Field Report: Findings from a brief field assessment of selected wetlands within a 500m radius of the N2 Wild Coast Toll Highway Project between the Msikaba and Mthentu bridges.

Compiled by Steven Ellery (Pr.Sci.Nat – Ecology, MSc - Geography)

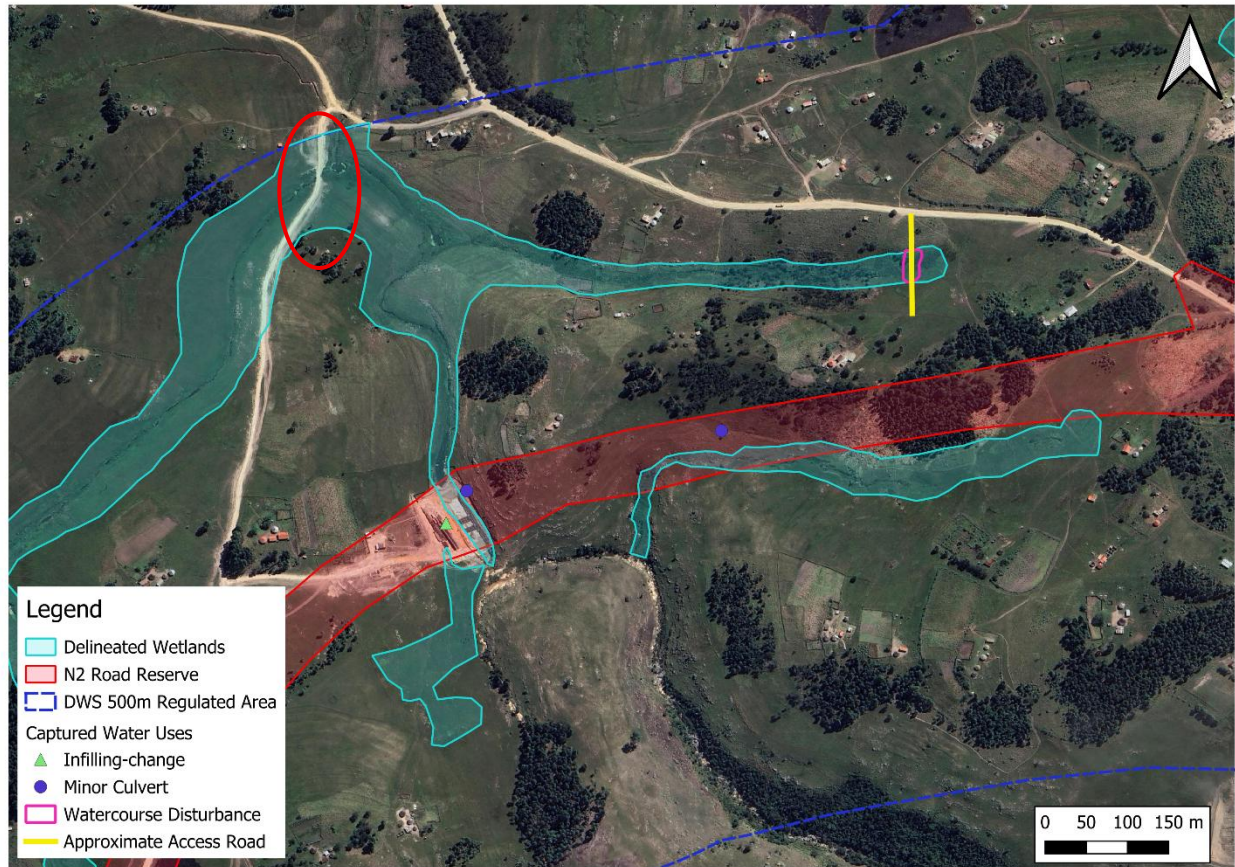
Figure 12 highlights a second instance where there is no known authorisation for the road that has been constructed, and the road is similarly not reflected on the access road map shown in Figure 10. It appears that this road has been constructed as a shortcut, so that vehicles can drive directly south to the road reserve as opposed to driving east before the existing road joins with the road reserve. It is noted that this road did not exist in its current extent in May of 2022, but it appears in the Google Earth image from March of 2024. It is noted that a small track does appear in the Google Earth image in May of 2022.

Figure 12 The captured water uses overlaid with the delineated wetlands. Note that there is no authorisation at the location where the road crosses this wetland highlighted by the red oval (CI number 30). An additional access road and associated disturbance is shown by the yellow line and pink polygon (CI numbers 5, 18 and 31).

Furthermore, several access roads shown on the EMC planning map appear to have unclear construction-related objectives and, in certain instances, may represent unnecessary disturbance, particularly where they involve additional crossings through wetlands or watercourses (as represented by the yellow line and pink polygon in Figure 12 and shown in Figure 13). The road crossing appears to lead to a household and has not yet been linked in any clear way to the construction site. While this road is shown on the EMC map in Figure 10, the questions regarding 1) the necessity of the road and 2) why the road was placed through a wetland in the first place are raised. If this road had been planned appropriately, and had been appropriately checked by the resident engineer and environmental compliance officer, simply moving the road 30m upslope would have been sufficient to minimise damage to the wetland. This raises concerns not only regarding possible authorisation gaps, but also whether the project has adequately minimised the number and extent of access routes through sensitive aquatic ecosystems.
